CITY OF ALBUQUERQUE

RE: Lot 11 Block 9 Unit 5 S.A.D. 227 6201 Casa Blanca NW Grading and Drainage Plan Engineers Stamp Date 9/26/19 (E10D065)

LOT11 BL9 U5 VOLCANO CLIFFS 6201 CASA BLANCA RD NW GRADING AND DRAINAGE PLAN

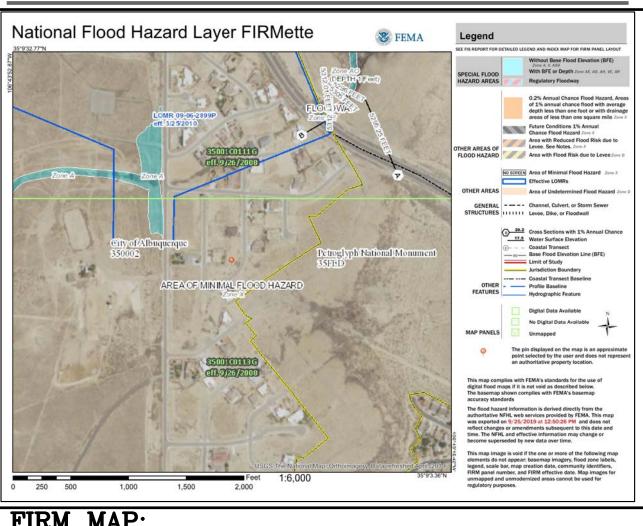
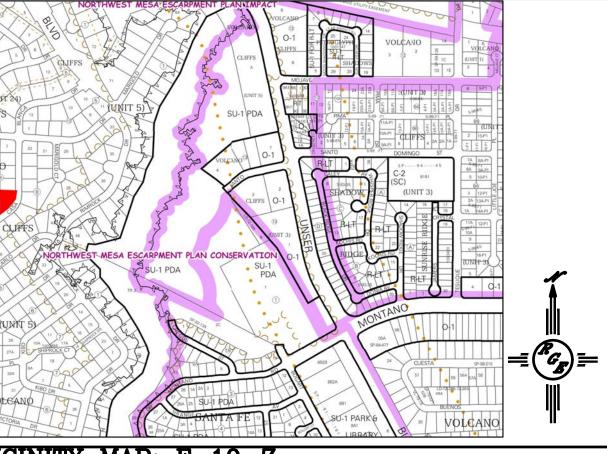
Based upon the information provided in your submittal received 9/25/19, this plan is approved for Grading Permit. Please inform the builder/owner to attach a copy of this approved plan and letter into the construction sets in the permitting process prior to sign-off by Hydrology.

Reiterate to the Owner/Contractor that a separate permit for any garden/retaining wall must be obtained, with the approved G&D plan.

Prior to Building Permit approval, a **Pad Certification** will be required. Inform the contractor/owner not to pile dirt in the street as a ramp to climb the curb. If dirt is found in the street the pad cert. will be denied.

Prior to **Certificate of Occupancy release**, Engineer Certification per the DPM checklist of this plan will be required.
